Chapter 6.0 Addendum to Design and Access Statement – Further amended plans July 2020.

Report No	Written By	Checked By	Revision	Issued
17061 Addendum to Design and Access Statement - D&A Chapter 6 REV A	MP	RB/PO	C02	23/07/2020

Figure 2 – Re-profiled section

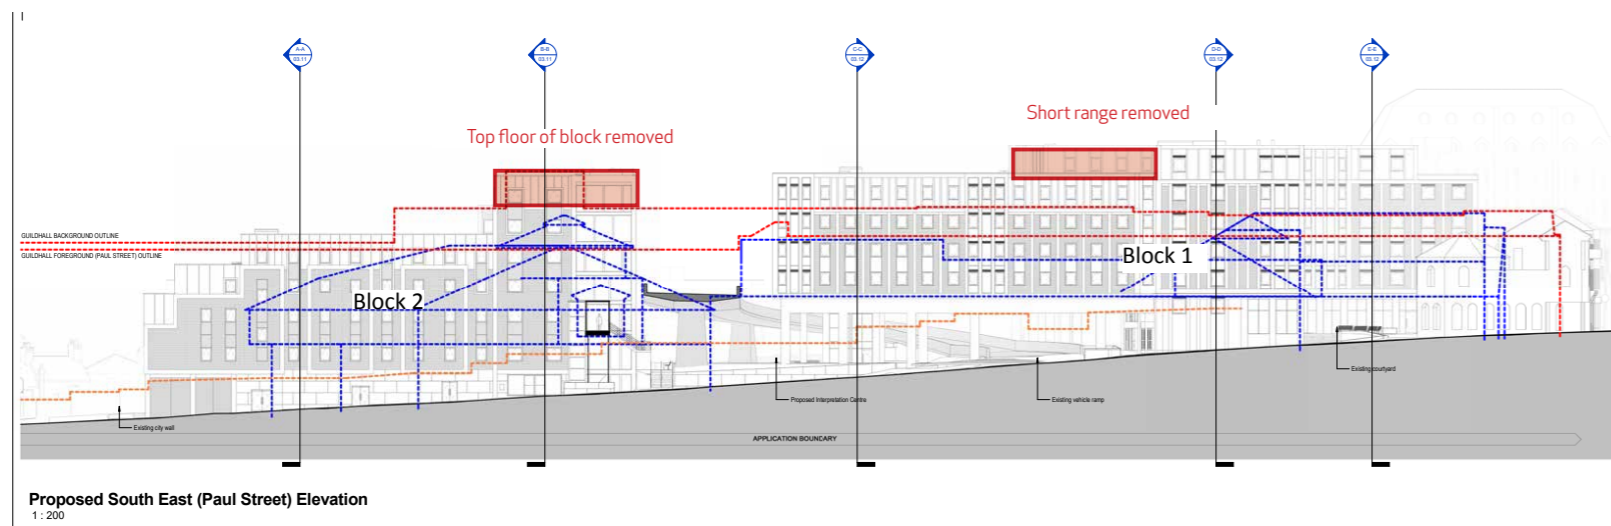
Since the original planning application, the height of both buildings has been significantly reduced. However further measures have been taken to reduce the overall height and massing of the development following further discussions with Exeter City Council planning officers and Historic England.

The removal of further accommodation from the building focuses on two areas the North East Range of Block 2 and the short-range to the south-west of the north-east range of Block 1:

The removal of an entire storey from Block 2 resulting in the loss of 13 hotel bedrooms.

The removal of part of the fifth-floor level which results in the reduction of the block by 8 bedrooms.

The removal of the top floor level from both Block 2 and the rear section of Block 1 helps to provide an improved transition in height between the new development and the St David's and Central Conservation Areas resulting in a scheme which improves its response to the natural topography with both blocks stepping down in height along Paul Street towards the Iron Bridge and North Street.

Revised drawings showing area removed in red
